Product Change Notification

Change Notification #: 114869 - 01

Change Title: Intel® NUC Kit, NUC6i3SYH,
Intel® NUC Kit, NUC6i3SYK,
Intel® NUC Kit, NUC6i5SYH,
Intel® NUC Kit, NUC6i5SYK,
PCN 114869-01, Product Design,
Product Material,
BIOS Update and DIMM socket
modification,
Reason for Revision: SODIMM
socket modification

Date of Publication: September 12, 2016

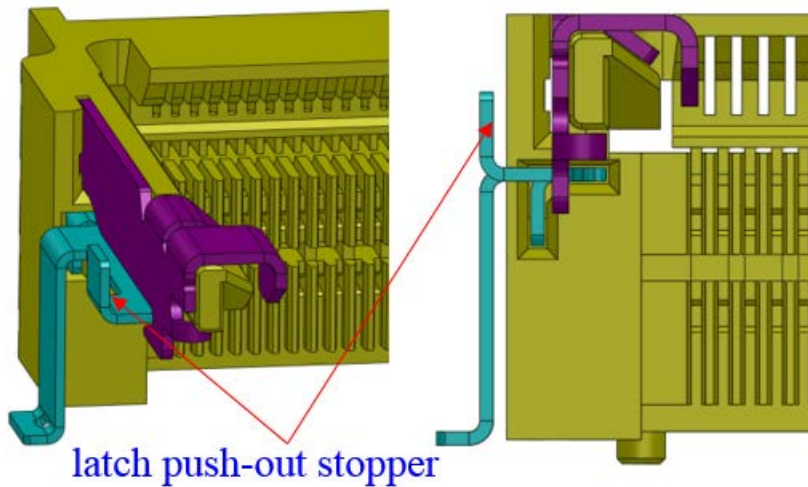
1. The BIOS will be updated from SYSKLI35.86A.0042 to SYSKLI35.86A.0051. To access the release notes or get a copy of the BIOS for evaluation, go to <http://downloadcenter.intel.com>.
2. The SODIMM socket is being modified. The latch stopper structure will limit the latch during mating and un-mating of the DIMM. See picture below

The change to the SODIMM socket is not expected to impact the product.
